Access Compliance Report Public Rights-of-Way (Curb Ramps)

Main Street: STARLIGHT_RIDGE Cross Street: CHAPARRAL_CT Location: NW

ADA ID: RPRK211018175219 Ramp Type: Type 4 - Parallel Initial Pass/Fail: Fail Overall Compliance: No Severity Score: 32

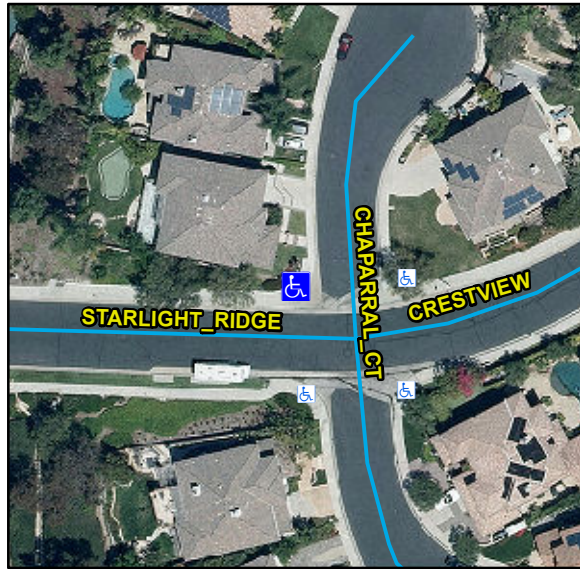
R304.5.3, R304.3.2, R302.7.2, STD 1115

Compliance	Description	Data	Compliance	Description	Data
N/A	Ramp Length LT (in)	80	N/A	Ramp Length RT (in)	104
Yes	Ramp Width LT (in)	90	Yes	Ramp Width RT (in)	92
Yes	Ramp Run Slope LT (%)	5.2	No	Ramp Run Slope RT (%)	14.6
No	Ramp Cross Slope LT (%)	2.1	Yes	Ramp Cross Slope RT (%)	1
N/A	Landing Present	N/A	N/A	DWS Provided	N/A
N/A	Landing Length (in)	N/A	N/A	DWS Contrast	N/A
N/A	Landing Width (in)	N/A	N/A	DWS Length (in)	N/A
N/A	Landing Run Slope (%)	N/A	N/A	DWS Full Width	N/A
N/A	Landing Cross Slope (%)	N/A		DWS Offset Type	N/A
N/A	Landing Movement Obstructed?	N/A	N/A	DWS Offset Left (in)	N/A
	Landing Movement Type	N/A	N/A	DWS Offset Right (in)	N/A
N/A	Landing Shared	N/A			
N/A	Clear Space	Yes			
N/A	Clear Space To Crosswalk (in)	N/A			
N/A	Marked Crosswalk 1	No	N/A	Marked Crosswalk 2	No
	Crossing 1 Direction	S		Crossing 2 Direction	E
	Marked Crosswalk 1 Width (in)	N/A		Marked Crosswalk 2 Width (in)	N/A
N/A	Ramp Inside Crosswalk 1	N/A	N/A	Ramp Inside Crosswalk 2	N/A

Crossing 1 Slope (%)	3.4		Crossing 2 Slope (%)	5.2
	Crossing 1 Cross Slope (%)	6.8		Crossing 2 Cross Slope (%)	5.9
N/A	Gutter Ponding	N/A	N/A	Curb Slope	3.2
No	Gutter Lip Height (in)	0.25		Road Run Slope (%)	10.4
N/A	Gutter Run Slope (%)	N/A		Road Cross Slope (%)	3.4
N/A	Gutter Cross Slope (%)	N/A	Yes	Perpendicular Joint Present	Yes
Yes	Overall Surface Condition	Acceptable			
	Cross Gutter Present?	Yes		Spandrel Present?	Yes
	Replace Cross Gutter?	No		Replace Spandrel?	No

Remove & Replace Curb Ramp With Two New Directional Ramps or Equivalent. Grind Gutter Lip.
